ARKANSAS
Department of Environmental Quality

RE: NPDES Compliance Inspection, Ravenden Springs Wastewater Treatment Plant

AFIN: 61-00095 NPDES Permit No.: AR0048712

NPDES Compliance Inspection Report

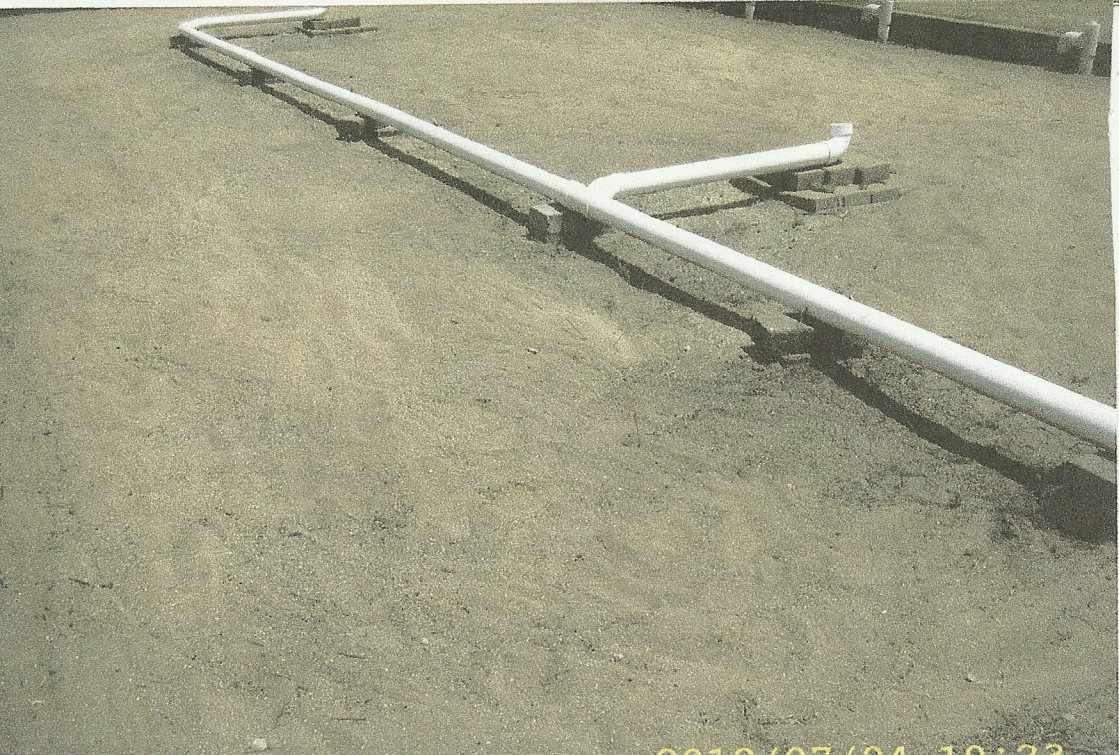
1. Improper operation and maintenance. This violates Part III Section B. Item 1.a. of the permit, which requires that the permittee shall at all times properly operate and maintain all facilities and systems of treatment and control (and related appurtenances) which are installed or used by the permittee to achieve compliance with the conditions of this permit. The following items were noted:

- a) Excessive vegetation was observed in the sand filters of the wastewater treatment plant.
 - b) Flow measurements were not measured in the proper location at least 3x head upstream of the weir. Head was incorrectly measured at the crest of the weir.

- c) The wet well cover was unlocked at the lift station in front of the First Baptist Church.
 - d) The pump was turned off and the alarm light was not operational on the lift station behind the residence located at 5 Glenhill Drive. It also appeared that the float switches were not functioning properly to activate the alarm light and to activate or shut off the pump in the wet well.

- e) The lift station next to Hwy 90 was overgrown with vegetation and did not appear accessible for inspection and maintenance.

I have doon ever thing you asked for I hope the pichters are good .

We recieved your letter on the 26th of June ,do to a death in the family and the holiday and the time you gave us,I am sending you this though an e-mail. I tried to call you afew time and couldn't reach you. Everything you ask us to do we have done . If there is anything else Please call us at: 870-810-1653 sec or 870-810-1652
